LASALLE COUNTY STATION UNIT 1
STRUCTURAL BOLTING TIGHTNESS INSPECTION PROGRAM
FOR CONTAINMENT VALVES

I N S P E C T I O N R E S U L T S
(Inspection Performed July 1, 2, 6, & 7, 1982)

LASALLE COUNTY STATION UNIT 1
STRUCTURAL BOLTING TIGHTNESS INSPECTION RESULTS
FOR CONTAINMENT VALVES

VALVE NUMBER 1B21-F005 SERIAL NUMBER A1786

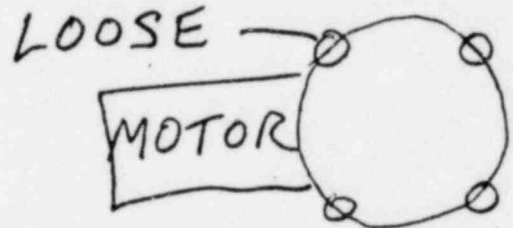
INSPECTED/TIGHTENED 3 BOLTS W/ BOX WRENCH

PROBLEMS FOUND/CORRECTIVE ACTION TAKEN ONE BOLT MISSING ON SWITCH HOUSING COVER - REPLACED

VALVE NUMBER 1B21-F016 SERIAL NUMBER 1N-245*

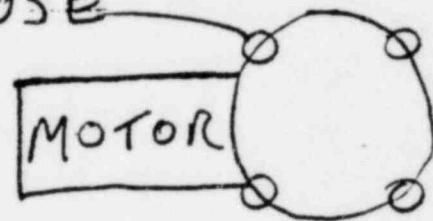
LOOSE

PROBLEMS FOUND/CORRECTIVE ACTION TAKEN 2 BOLTS LOOSE
ON SWITCH HOUSING COVER - TIGHTENED

VALVE NUMBER 1E12-F009 SERIAL NUMBER E5875-16-1

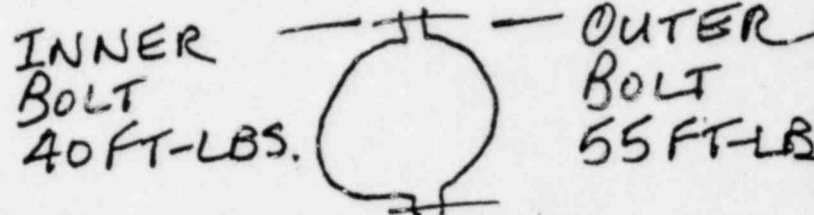
VALVE HOT - LOWER BOLTS

PROBLEMS FOUND/CORRECTIVE ACTION TAKEN 1 BOLT MISSING ON SWITCH HOUSING COVER HINGE - REPLACED.

BOLTS OK. POSSIBLY - DUE TO TIGHTENING UPPER BOLTS
